Woollahra Local Planning Panel (Public Meeting)

Thursday 5 September 2024
1.00pm

LOCAL PLANNING PANEL SECTION 4.56 APPLICATION ASSESSMENT REPORT

ITEM No.	D1
FILE No.	DA436/2020/2
ADDRESS	18 Olphert Avenue Vacluse
COUNCIL WARD	Vacluse
ZONING	R2 Low Density Residential
EXISTING CONSENT	The demolition of an existing dwelling house and the construction of a new dwelling house and swimming pool and associated works
DATE OF CONSENT	29/11/2022
TYPE OF CONSENT	Local development
CONSENT AUTHORITY	Land and Environment Court
PROPOSED MODIFICATION	Modifications to the levels of the approved rear yard area/ swimming pool, landscaping and fencing modifications
TYPE OF MODIFICATION	Section 4.56
DATE S4.55 LODGED	02/01/2024 - original lodgement 18/07/2024 - amended application
APPLICANT	Ms S J Curtis
OWNER	Mr C D Taylor & Ms S J Curtis
AUTHOR	Mr D Booth
TEAM LEADER	Mr M Moratelli
SUBMISSIONS	7 to the original application 5 to the amended application
RECOMMENDATION	Conditional approval

4.56_1.2
RAISED POOL REV 2
BOUNDARY FENCES

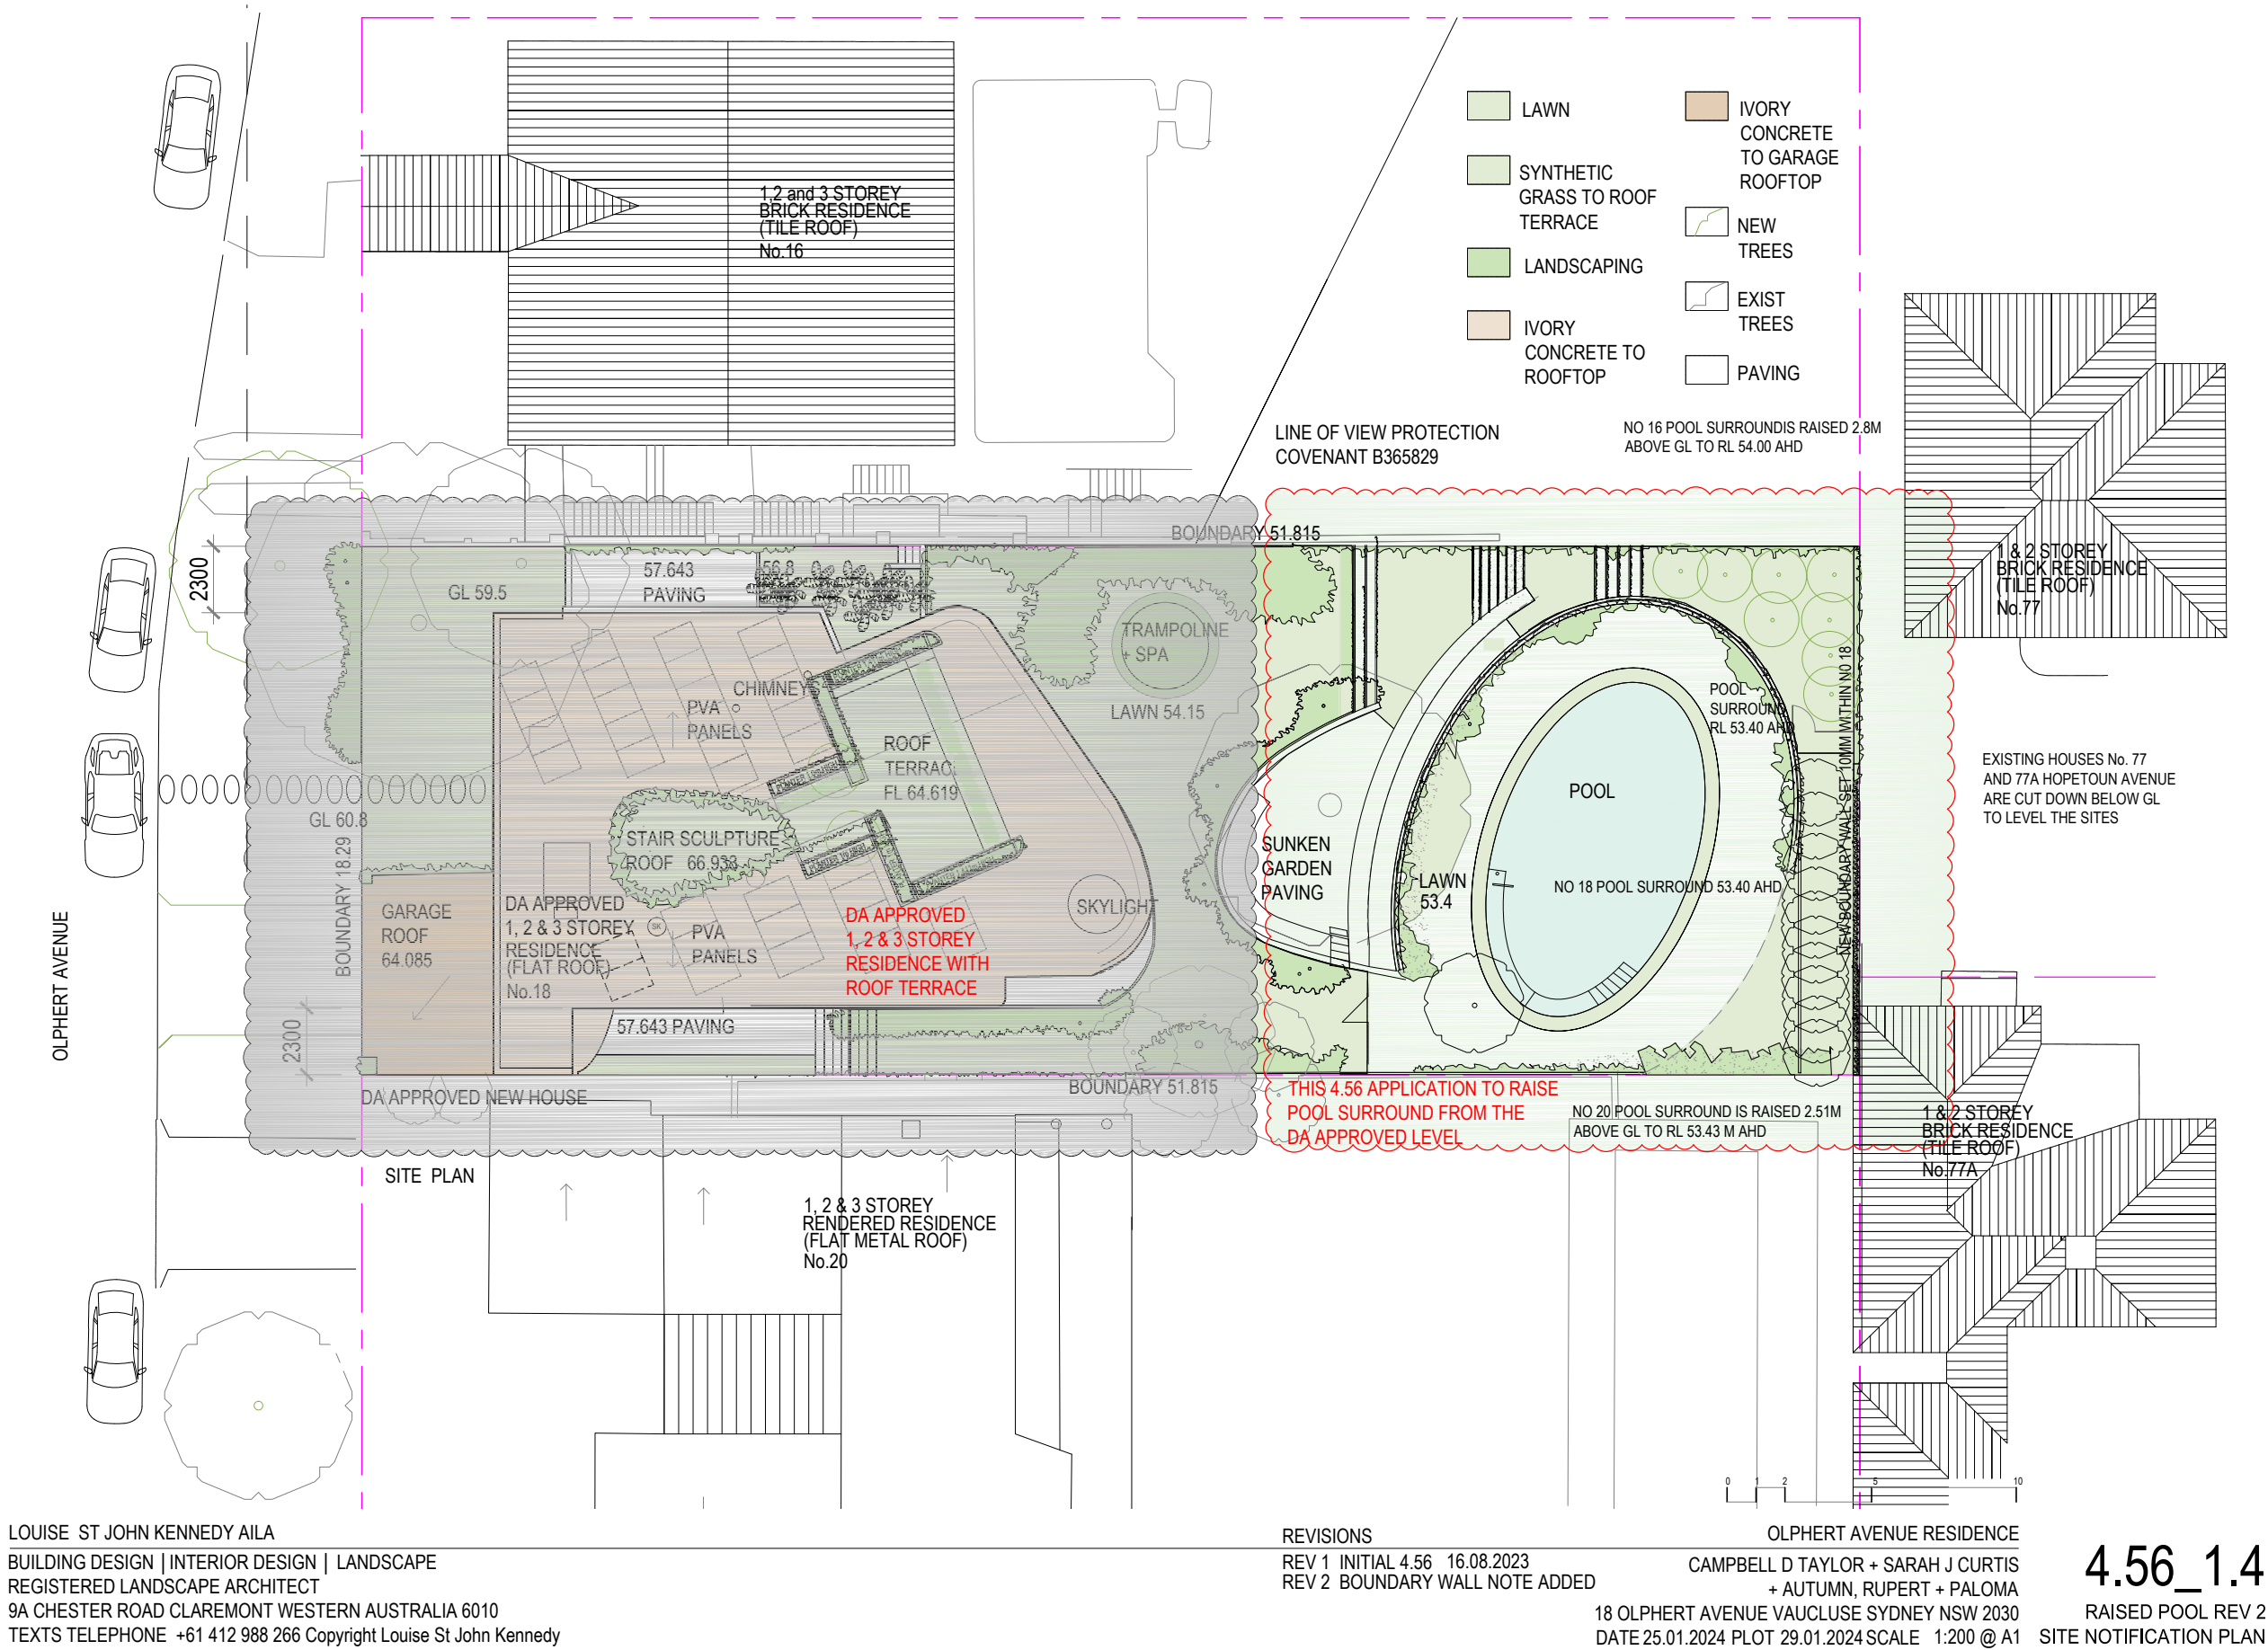
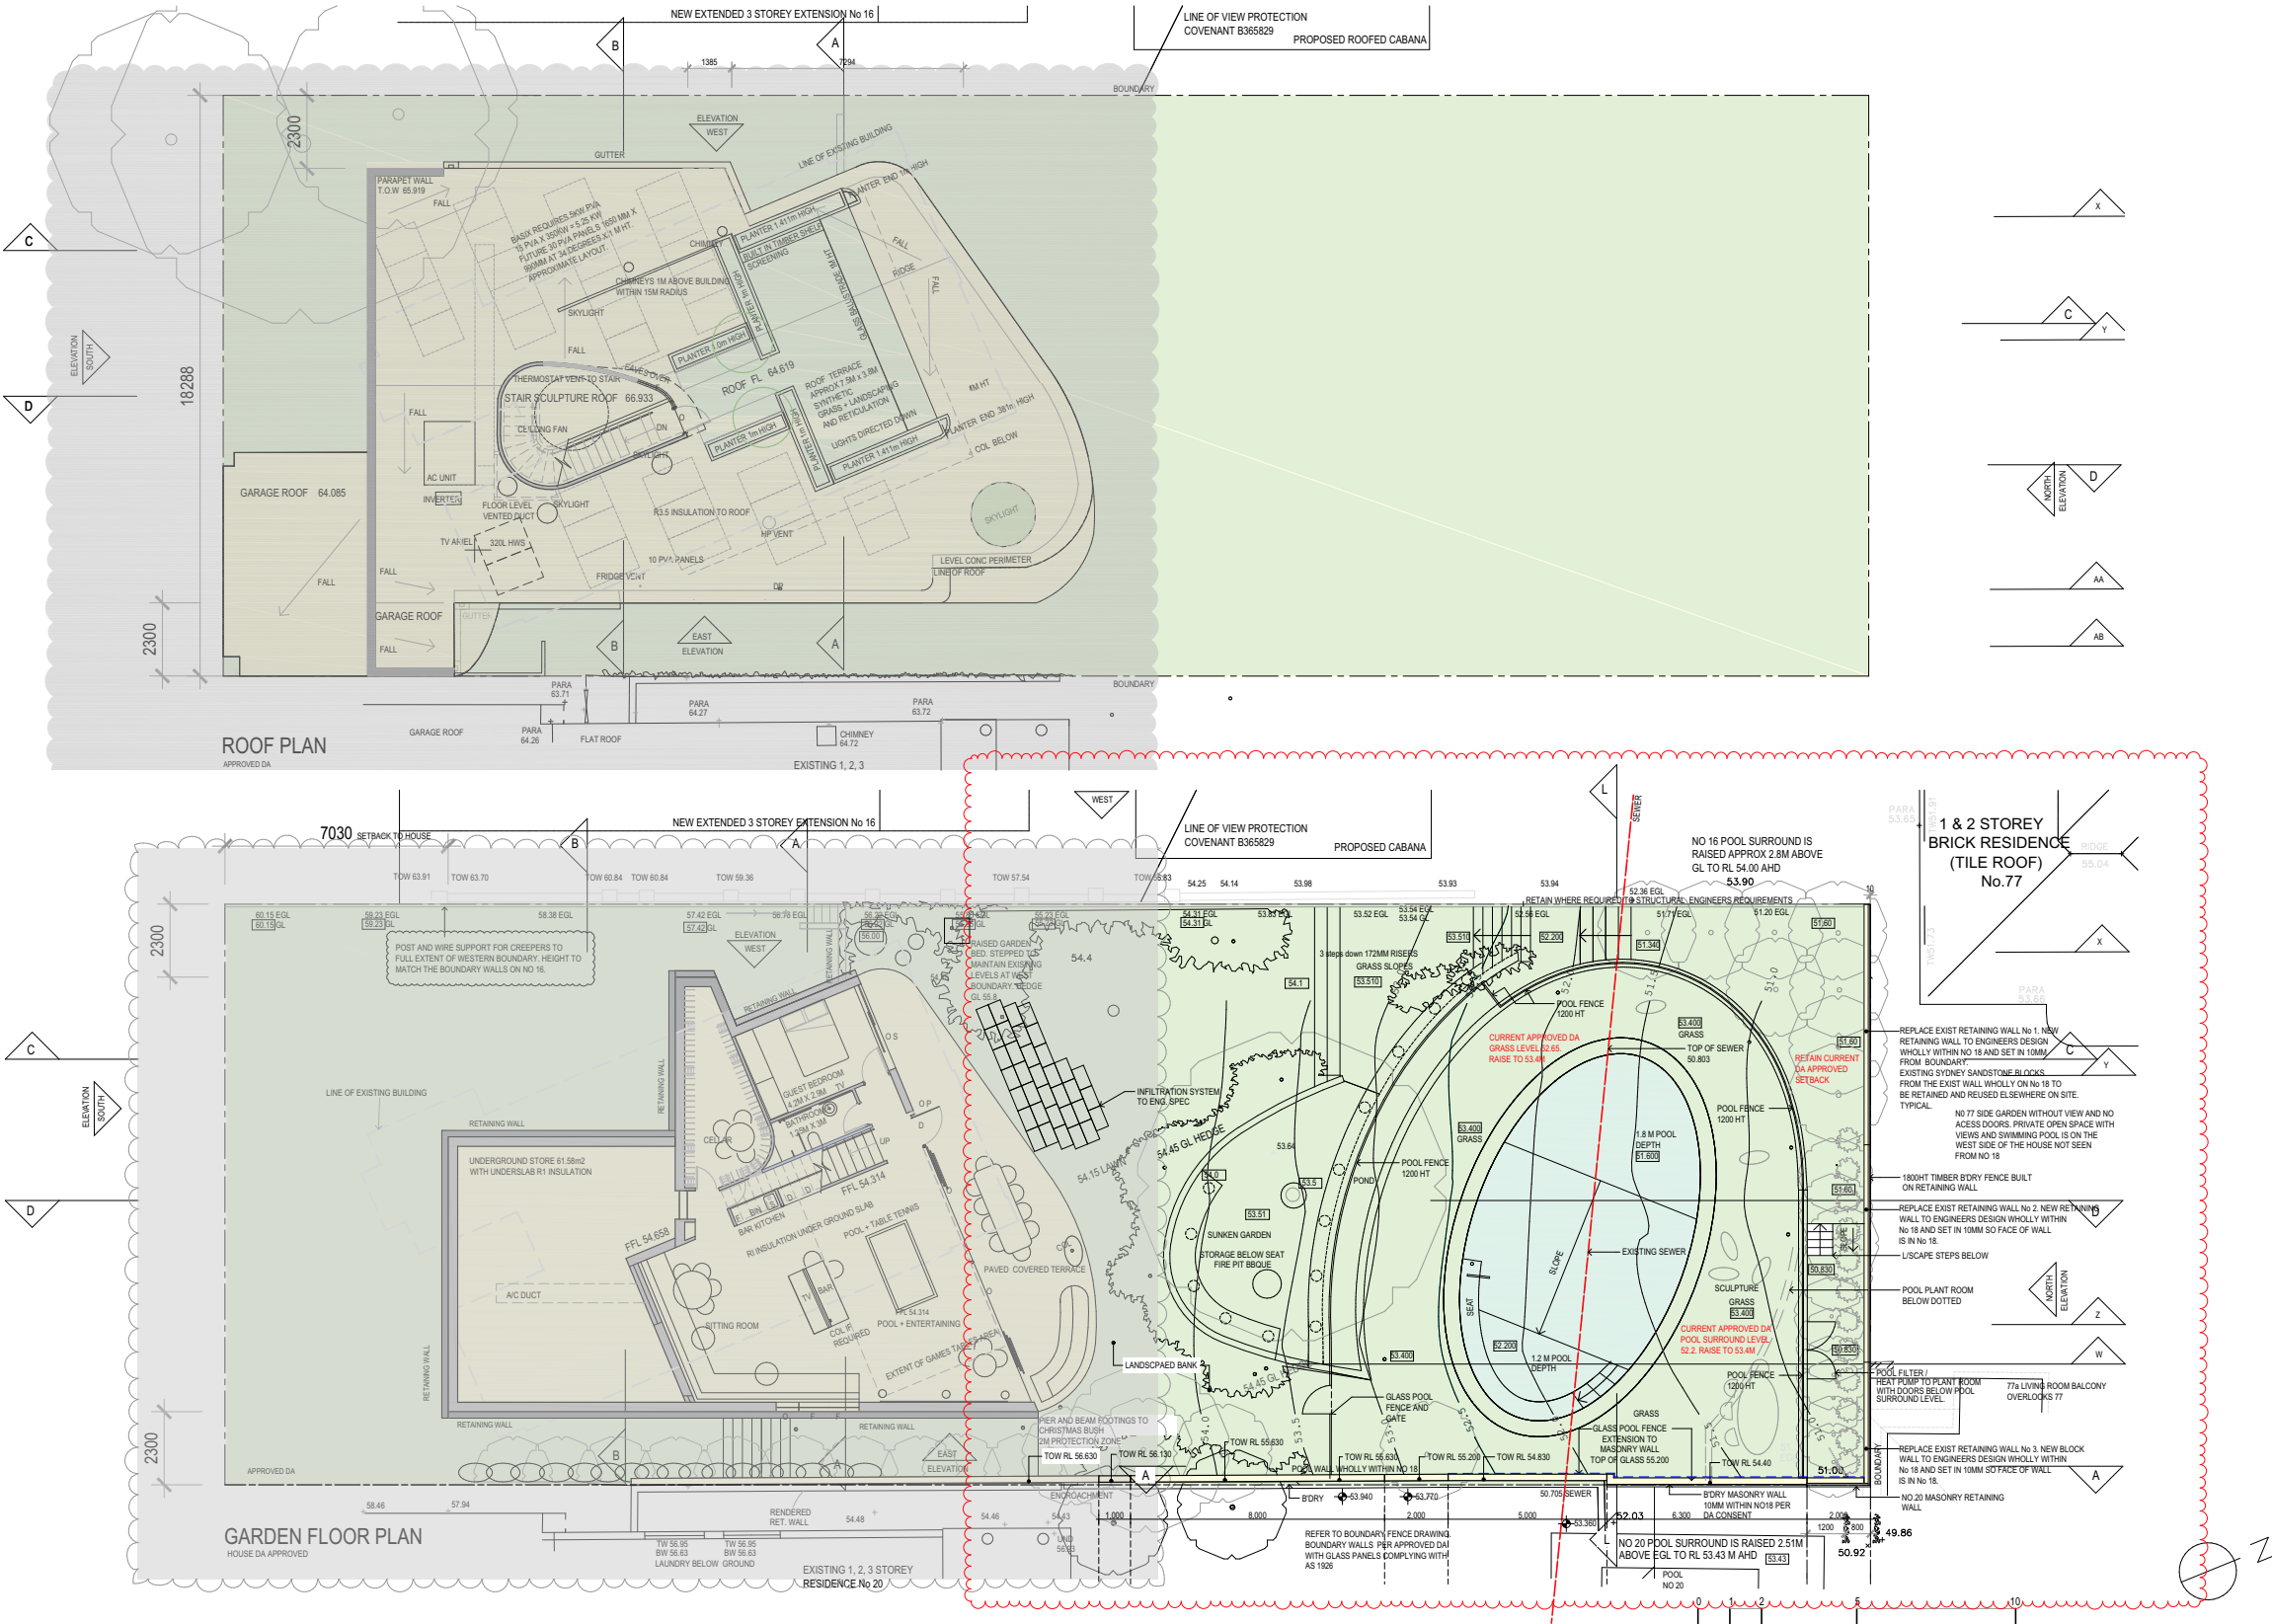
- *The north-south dimension of the pool plant room is inconsistently documented on drawing 4.56 1.2 compared with drawing 4.56 2.1.*

- e) Where the north-south dimension of the proposed pool plant room is inconsistently documented on drawing 4.56 1.2 compared with drawing 4.56 2.1, the lesser dimension documented on drawing 4.56 2.1 prevails.

4.56_2.1
RAISED POOL REV 2
PLAN GARDEN + ROOF

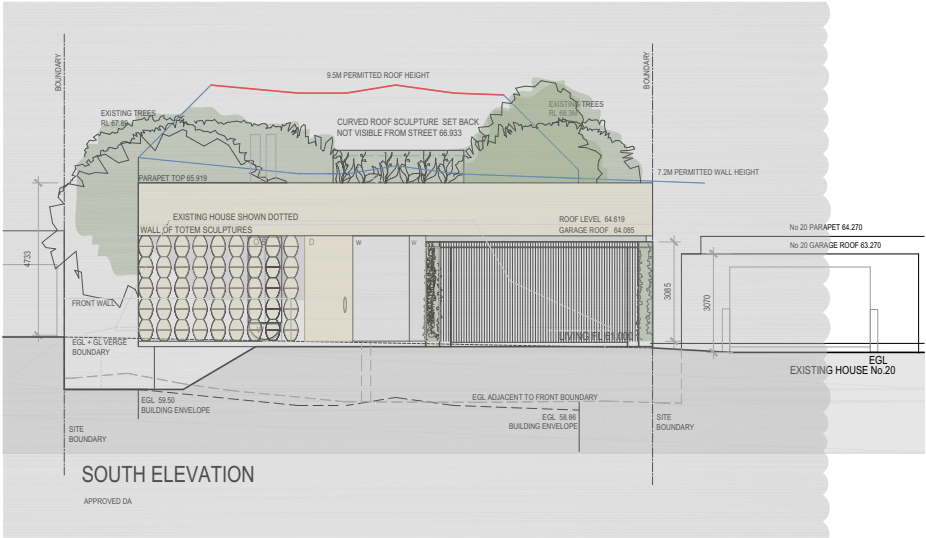
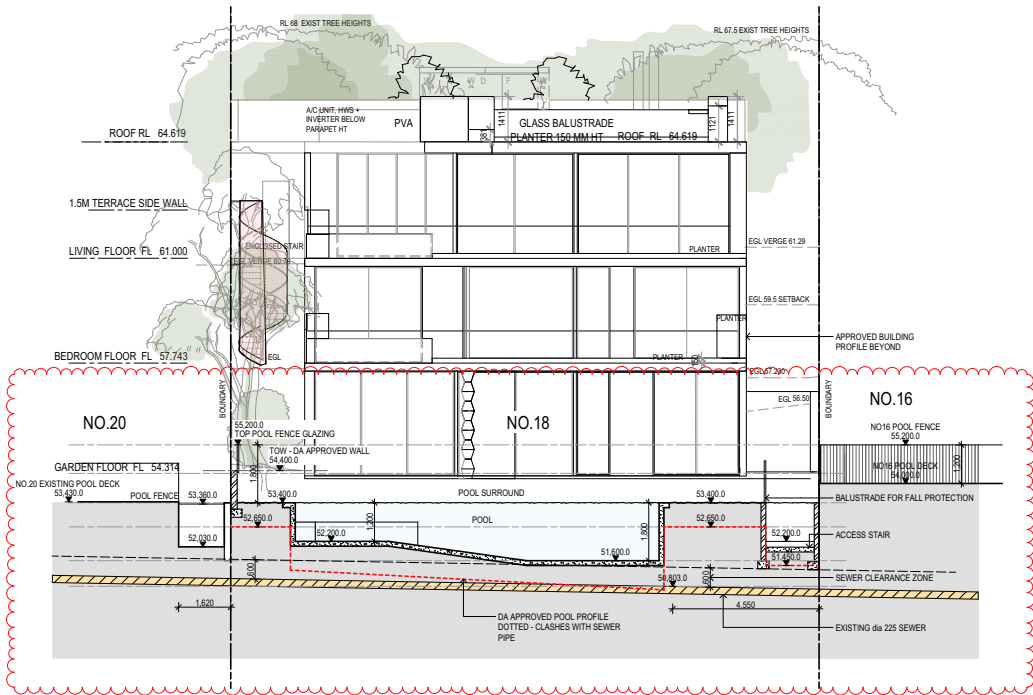
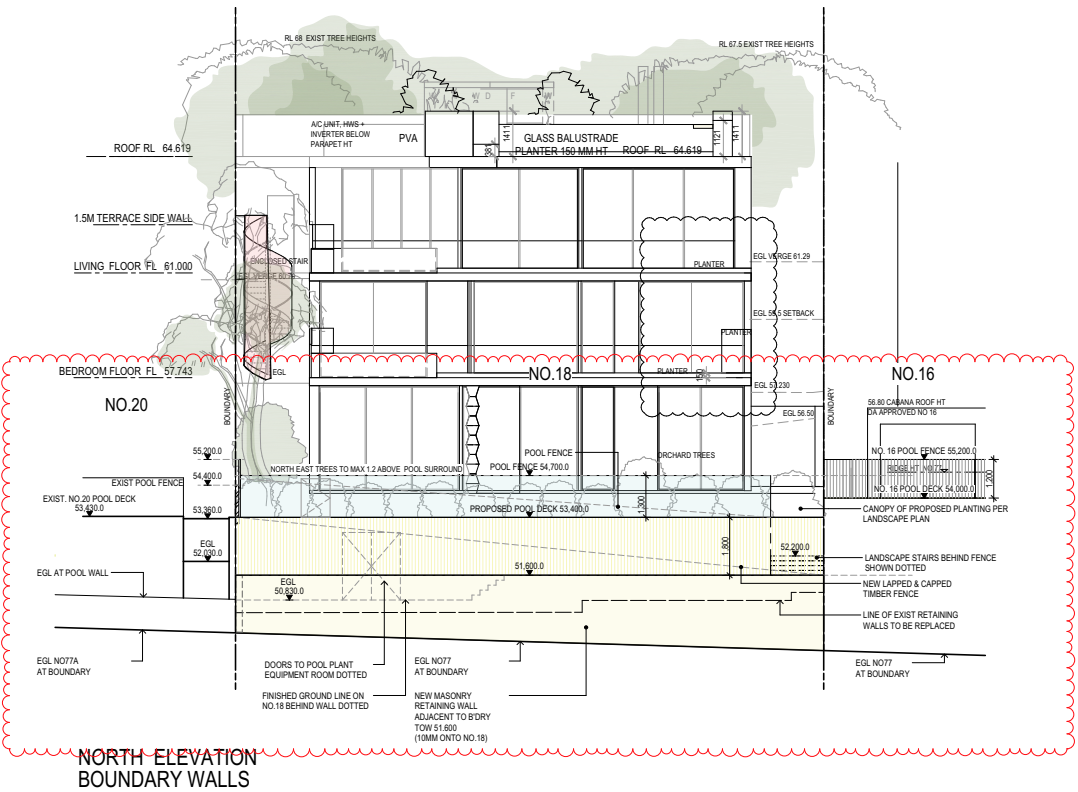
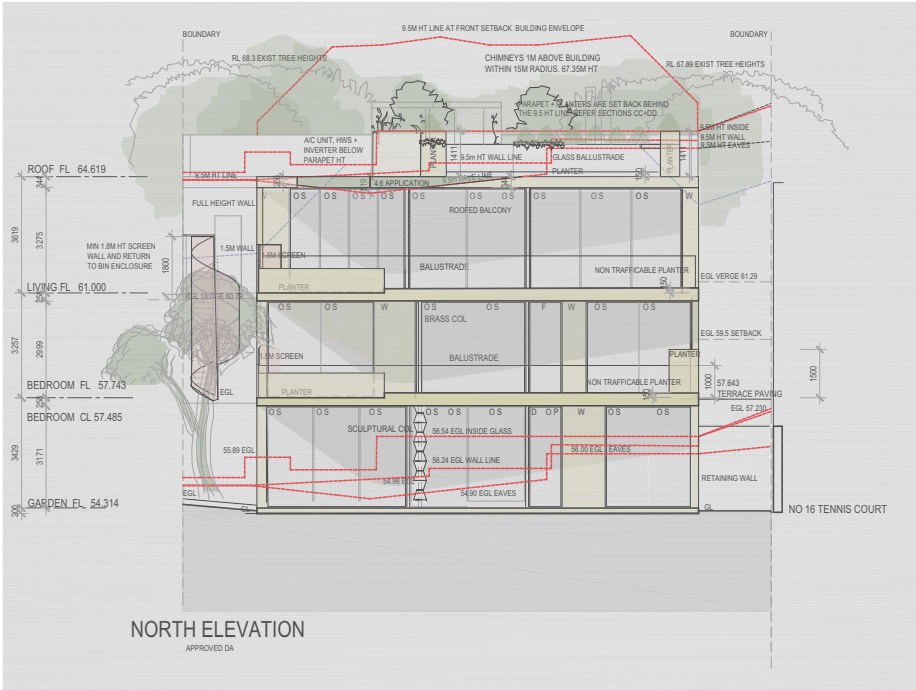
- *Drawing 4.56 2.1 references "No. 20 masonry retaining wall" and such is also documented on drawing 4.56 3 Section L with the subject eastern boundary pool fence butting up against it and is relied upon to retain the proposed additional fill to the swimming pool surround. The retaining wall does not exist and landowners' consent is not granted for the construction of a retaining wall on 20 Olphert Avenue.*

The replacement of the approved spa with a transplanted frangipani tree spa on the Landscape Plan is not contained within the red clouded area formally documenting the scope of the proposed modifications. However, the approved spa has been removed from within the red clouded area on drawing 4.56_2.1 Garden Floor plan and an infiltration system added.

- f) Where the eastern boundary pool wall/ fence is inconsistently documented on drawings 4.56 2.1 & 3.1 compared with drawing 4.56 3 Section L, the documentation on drawings 4.56 2.1 & 3.1 prevail.

- g) Where the deletion of the approved spa/ addition of an infiltration system is inconsistently documented on drawing 4.56_2.1 Garden Floor plan compared with drawing 4.56_4.1 Section CC, the documentation on drawing 4.56_2.1 Garden Floor plan prevails.
